**PR/1556/22**

## Record of Executive Business and Chief Executive's Order

**Reg. Reference:** SD22B/0465      **Application Date:** 24-Oct-2022  
**Submission Type:** New Application      **Registration Date:** 24-Oct-2022

**Location:** Cottbrook, Castlekelly, Bohernabreena, Co. Dublin, D24 YY42

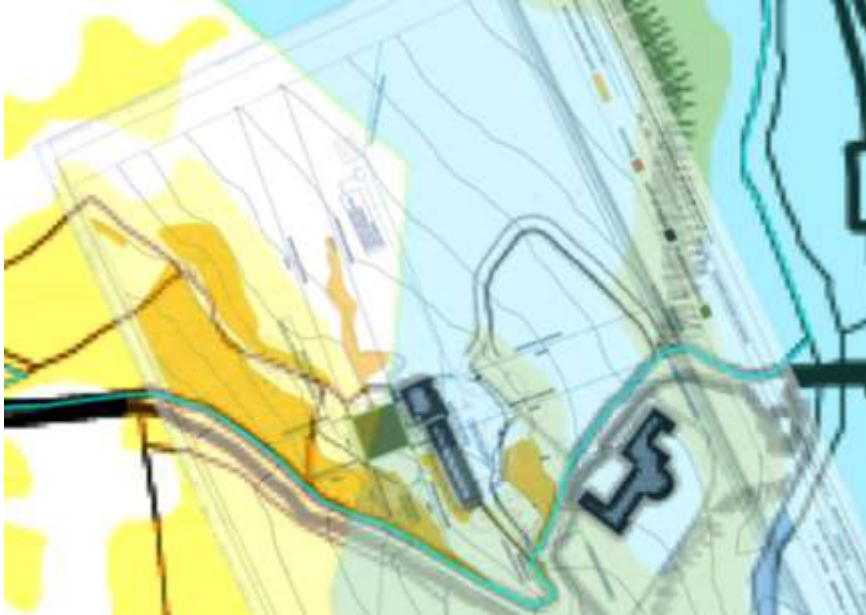
The site appears to be located within a Core Area and the Dodder River Corridor Primary GI Corridor, as per Figure 4.4 of the Development Plan. The site is also located within the 100m zone from streams and slope greater than 20% area, shown on the *'Map showing the Restricted Areas for Development Glenasmole and Bohernabreena'*, per Appendix 5 of the Plan. The site is therefore considered to be highly sensitive.

The applicant has indicated on site plans a line for the 100m zone from streams and slope greater than 20%. It is not immediately clear how these areas have been plotted. From a review of the map included at Appendix 5, it appears that a significant portion of the site is included within these areas, including the area where the extension is proposed. The below image provides an overlay of the development site and proposed extension, with the map contained in Appendix 5, highlighting the discrepancy between the applicant's submission and the provisions of the Development Plan.

The applicant should be asked to clarify how the lines and areas on their site layout plans were plotted and address the discrepancy of the map contained at Appendix 5, as **additional information**.

6. It appears from a review of Appendix 5 of the Development Plan that the area for which development is proposed overlaps with both the 100m zone from streams and slope greater than 20% layers of the Map showing the Restricted Areas for Development Glenasmole and Bohernabreena. The applicant has indicated these areas on layout plans however, there is a discrepancy in the areas shown on the applicants submission, and the areas shown on the map contained at Appendix 5. The applicant is requested to clarify this item, updating maps as necessary or confirming how conclusions were reached on site about where these layers have been shown.
